Agenda Item #: 8

SUB-002734-2023, MOD-002739-2023 & MOD-002740-2023

The Pines at Heron Lakes Subdivision

- Subdivision approval to create 82 legal lots of record
- Modification of a previously approved Planned Unit Development
- Modification of a previously approved Planning Approval

SITE PLAN

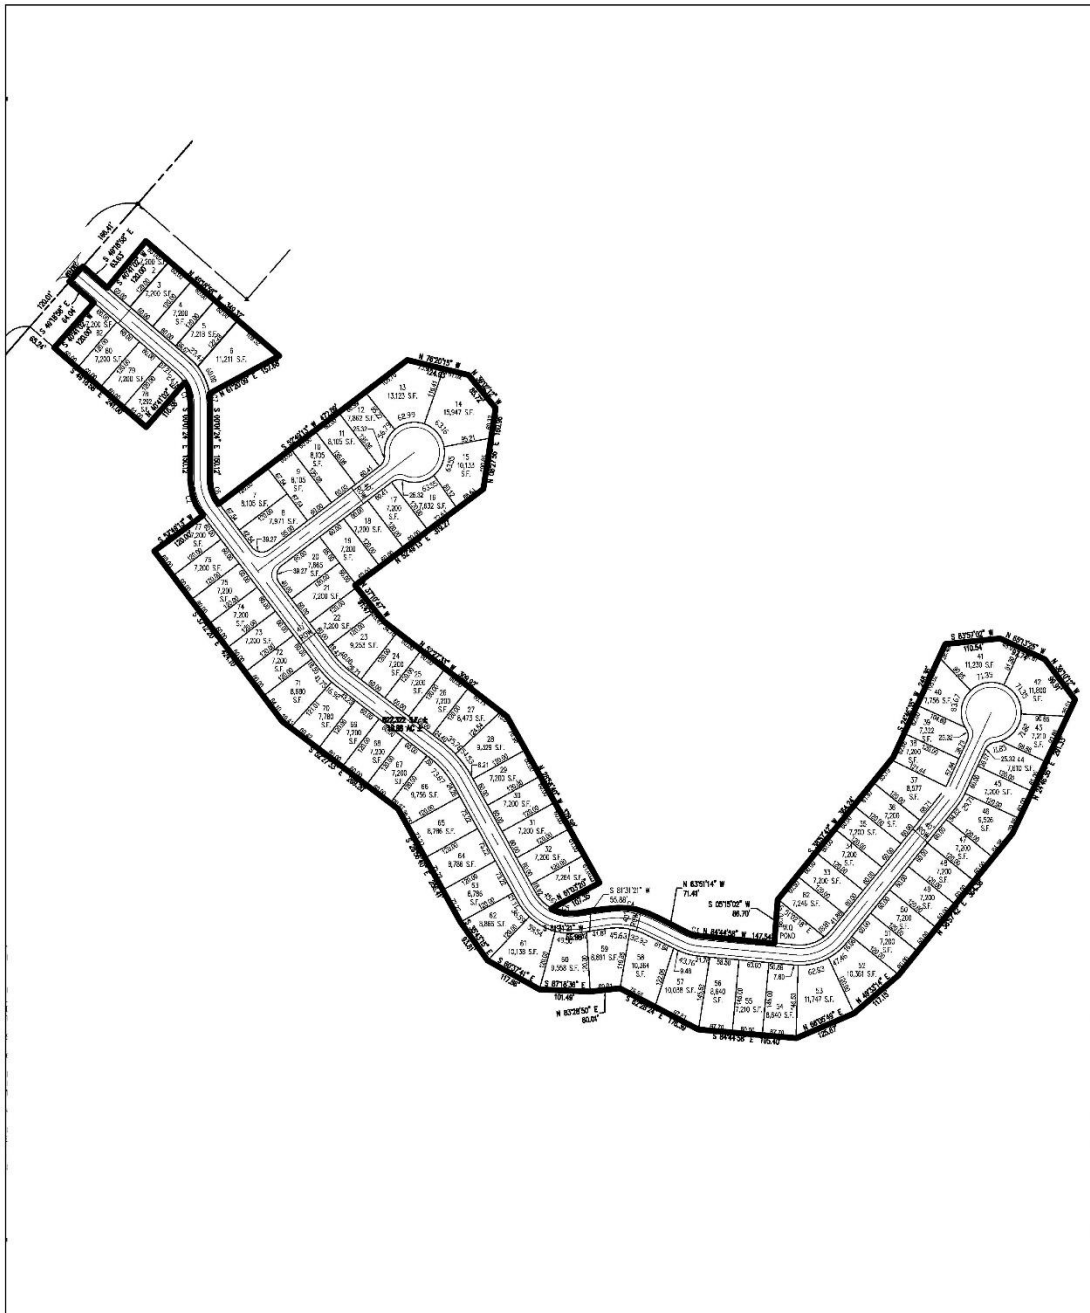
A single private street consisting of two (2) cul-de-sacs is proposed, both of which are unnamed on the preliminary plat. Each of the lots, with the exception of proposed Lots 9-19, have frontage on the long street.

Proposed Lots 9-19 have frontage on the shortest of the two cul-de-sacs. Both proposed streets are depicted with a 40-foot right-of-way, which is incompatible with the minimum 50-foot right-of-way requirement of Section 6.B.9. for streets equipped with curb and gutter. As such, if approved, the plat should be revised to depict a minimum 50-foot right-of-way along both proposed streets. Section 9.1(b)(2) of the Subdivision Regulations allows the Commission to waive curb and gutter requirements if sufficient evidence of unusual difficulties preventing their construction is accepted by the City Engineer. If the City Engineer waives the curb and gutter requirements, then the plat should be revised to depict a minimum 60-foot right-of-way along both proposed streets, per Section 6.B.9.

Proposed Lots 8 and 20 are corner lots, each requiring at least a 25-foot corner radius where the private streets will intersect. This information is not provided on the preliminary plat; therefore, if approved, the plat should be revised to illustrate at least a 25-foot corner radius where each lot abuts the private street intersection, in compliance with Section 6.B.12.

Both private streets are illustrated as closed-end streets with turnarounds, in compliance with Section 6.B.3, but the diameters of their rights-of-way are not depicted. For closed-end streets the right-of-way diameters are determined by the City Engineer and must comply with the most recently adopted International Fire Code (IFC). If approved, the plat should be revised to depict the right-of-way diameter for each turnaround, as approved by the City Engineer.

Proposed Lots 1, 38, 54, 56, 61, and 62 do not meet the minimum 60-foot width requirement of Section 6.C.2(b)(2) for residential lots located within the suburban sub-district, but only by a few feet. However, the size of the parent parcels from which the lots are proposed to be subdivided provide adequate area to provide compliant lot widths. If the plat is approved with the reduced lot widths, a waiver of Section 6.C.2(b)(2) will be required.

No front yard setbacks are illustrated on the preliminary plat. Section 6.C.8 requires front yard setbacks to be illustrated on every lot on the subdivision plat, in compliance with the dimensional requirements of Article 2 of the UDC for the underlying zoning district. As such, if approved, revision of the plat should be required to illustrate at least a 25-foot front yard setback where each lot is at least 60 feet in width, adjusted for any required dedication, per Article 2, Section 64-2-5.E. of the UDC for lots in the R-1 suburban district.

One (1) common area, labeled W.Q. Pond, is proposed to abut Lot 82. No information regarding its size is depicted, as required by Section 5.A.2(f). If approved, the size of the common area should be provided in square feet and acres on the revised plat. A note should also be placed on the revised plat, if approved, stating that the maintenance of all common areas is the responsibility of the property owners and not the City of Mobile, in compliance with Section 2.A.

The lot numbering, as proposed, is erratic (e.g. Lot 1 is adjacent to Lot 32, Lot 82 is adjacent to Lot 33, etc.). Additionally, the lot proposed to abut Lot 80 is not labeled with a lot number or letter. If approved, the plat should be revised to provide a more systematic numbering system, and to provide a lot number for the unlabeled lot.

The site plans reflect the changes proposed by the Subdivision request, but do not depict all of the properties overlaid by the PUD and Planning Approval. While no changes to the country club development are proposed with these modifications, they significantly modify the golf course. Consequently, the site plans for the Major Modifications to the PUD and Planning Approval should be revised to illustrate all properties within the PUD and Planning Approval.

2. Revision of the plat to depict adequate private street rights-of-way, as approved by the City Engineer;
3. Revision of the plat to provide names for each street;

4. Revision of the plat to depict 25-foot corner radii where Lots 8 and 20 abut the intersection of the proposed private street;
5. Revision of the plat to depict adequate turnaround diameters where each private street will terminate, as required by the City Engineer;

9. Revision of the plat to provide the sizes of each lot as adjusted for required dedication;
10. Revision of the plat to illustrate all lots will be at least 60 feet wide, unless granted a waiver of Section 6.C.2(b)(2) of the Subdivision Regulations;

11. Revision of the plat to illustrate the 25-foot minimum front yard setback where each lot is at least 60 feet wide;
12. Revision of the plat to provide the size of the proposed common area, in square feet and acres;

14. Revision of the plat to correct the lot numbering.
